United States Department of the Interior

NATIONAL PARK SERVICE
Southeast Regional Office
Atlanta Federal Center
1924 Building
100 Alabama St., SW.
Atlanta, Georgia 30303

DEC 19 2016

The National Park Service (NPS) appreciates the opportunity to be a cooperating agency with the Nuclear Regulatory Commission (NRC) and the U.S. Army Corps of Engineers (USACE) for the development of the Final Environmental Impact Statement (FEIS) regarding Combined Licenses for Turkey Point Nuclear Plant Units 6 and 7 as proposed by Florida Power and Light (FPL). We appreciate the extensive work done by the NRC and the USACE staff and their willingness to meet extensively with the NPS. However, the NPS continues to have serious concerns regarding the adequacy and accuracy of the FEIS. The NPS is also taking this opportunity to comment on the NRC's Final Safety Evaluation Report (FSER) because it describes natural phenomena, including hurricanes and storm surge, which may negatively affect Units 6 and 7 and have both human and environmental consequences for Biscayne and Everglades National Parks (NP).

Hurricane/Storm Surge Risk to Biscayne National Park

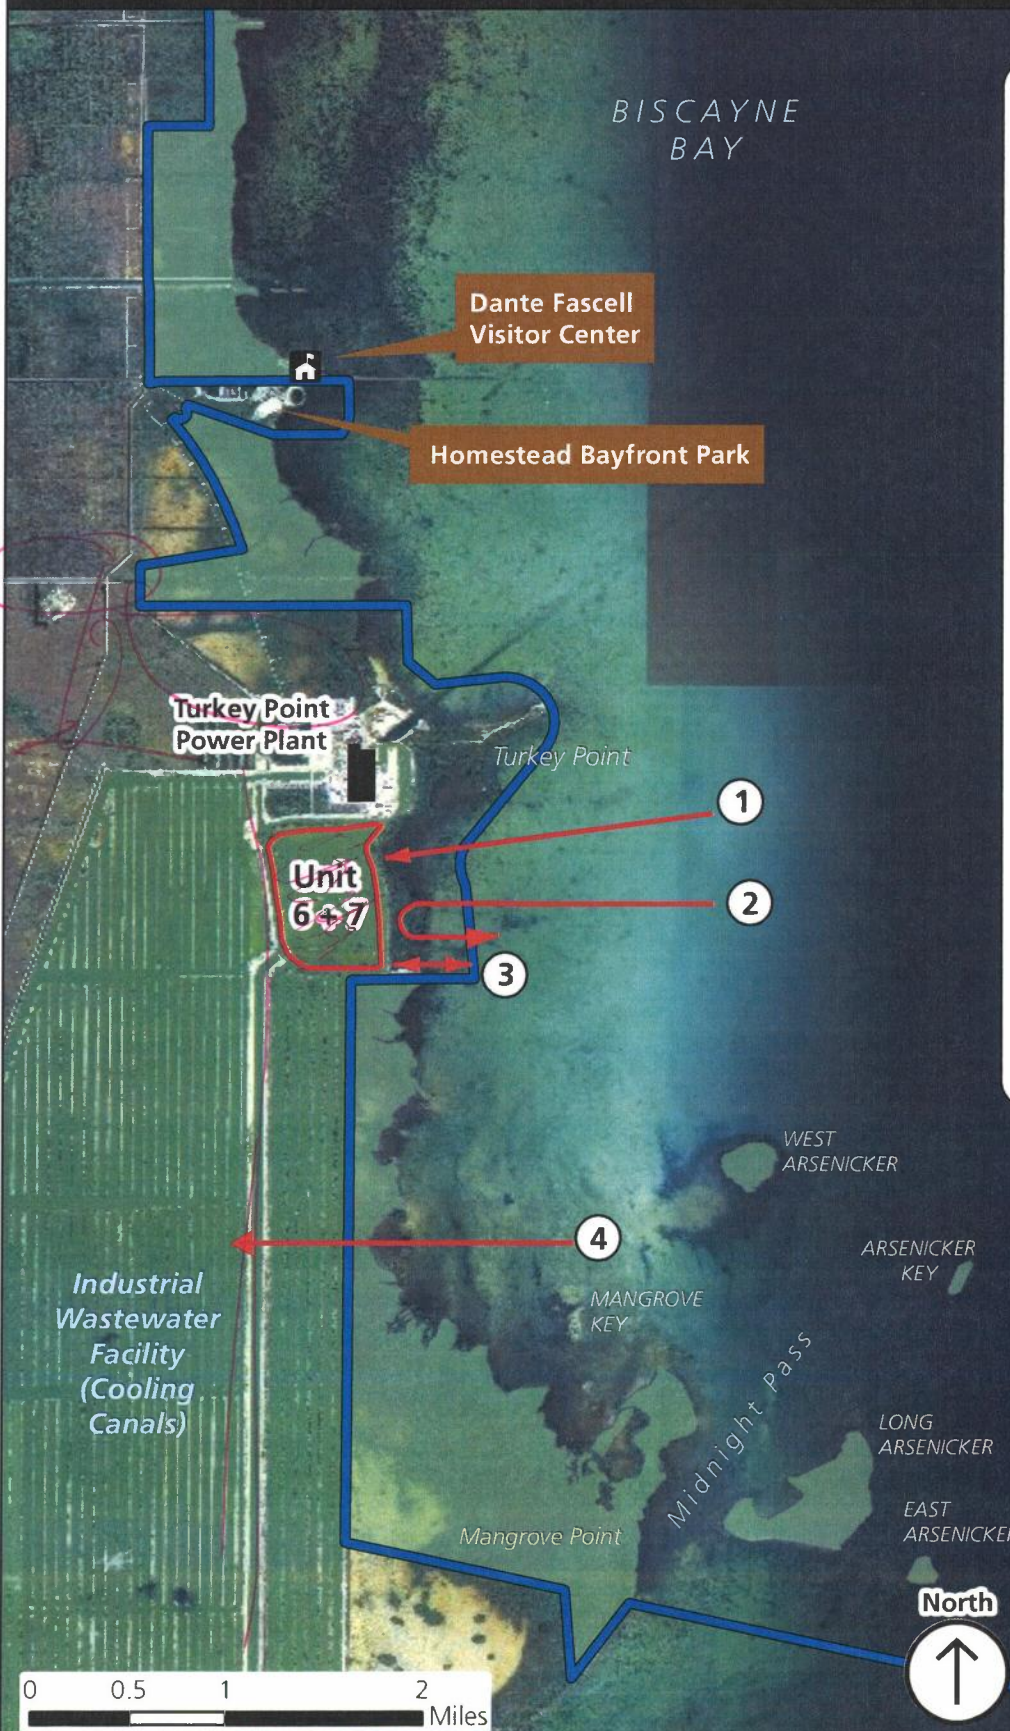
1. Placement of Units 6 and 7 would result in these Units being surrounded by the polluted canals of the Industrial Waste Facility (IWF). A portion of the IWF canals would be located between the outer walls of Units 6 and 7 and Biscayne National Park (NP) and Biscayne Bay (Bay).

2. It is reasonably foreseeable that a hurricane/storm surge event would wash over the IWF canal and its levee before contacting the outer eastern wall of Units 6 and 7. As the hurricane/storm surge event receded, it would draw polluted IWF water back into Biscayne NP and the Bay. This concern is not analyzed in either the FEIS or Safety Report.

3. There is also a high likelihood that such a storm surge event upon contact with the outer walls of Units 6 and 7 would be driven back toward the levee thereby causing a breach of the eastern levee and driving significant amounts of polluted IWF water into Biscayne NP and the Bay. Breaches of the levee further south would cause newly stored Units 6 and 7 dredge spoils to enter Biscayne NP and Bay. These concerns are not analyzed in either the FEIS or Safety Report.

4. The IWF is not a closed hydrologic system. It is connected to Biscayne NP and Bay, as documented by the presence of tritium (a tracer of IWF water) in Biscayne NP and Bay waters. Other IWF constituent pollutants concurrently enter Biscayne NP and Bay and pose significant ecological risk to the park and Bay.

Map titled "Modeled Storm Surge from Category 3 and Category 5 Hurricanes"

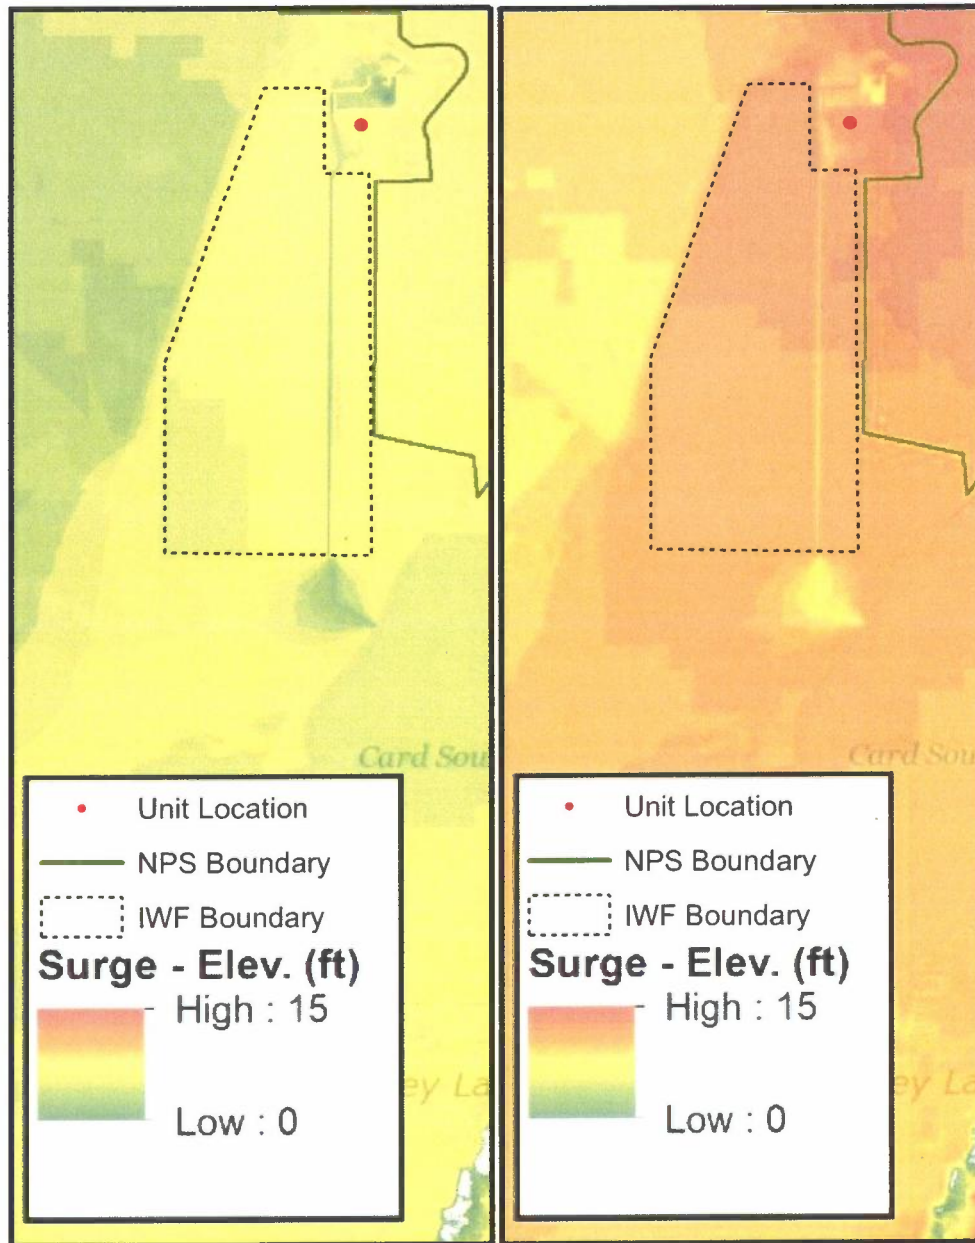
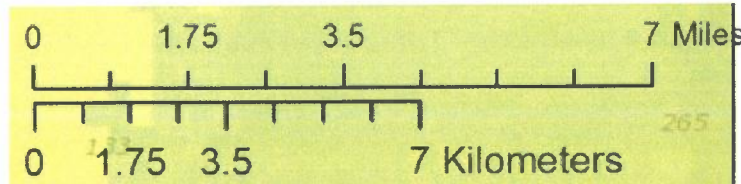
The Industrial Wastewater Facility (IWF) is highly susceptible to hurricane driven storm surge events. These two maps show outcomes from NPS runs of the National Weather Service's Sea, Lake and Overland Surges from Hurricanes (SLOSH) model conducted earlier this year. Both the Category 3 (left) and Category 5 (right) hurricane maps show anticipated storm surge based on high tide. Results indicate that storm surge waters would flow over levees separating the IWF from Biscayne National Park (NP) and Biscayne Bay (Bay). Such events increase the likelihood that contaminants in the IWF waters, as well as newly stored dredge spoils from Units 6 & 7 excavation, would enter Biscayne NP and Bay via overwashing and/or breach of the eastern levee (as discussed in accompanying map) in the foreseeable future. This concern is not analyzed in either the FEIS or Safety Report.
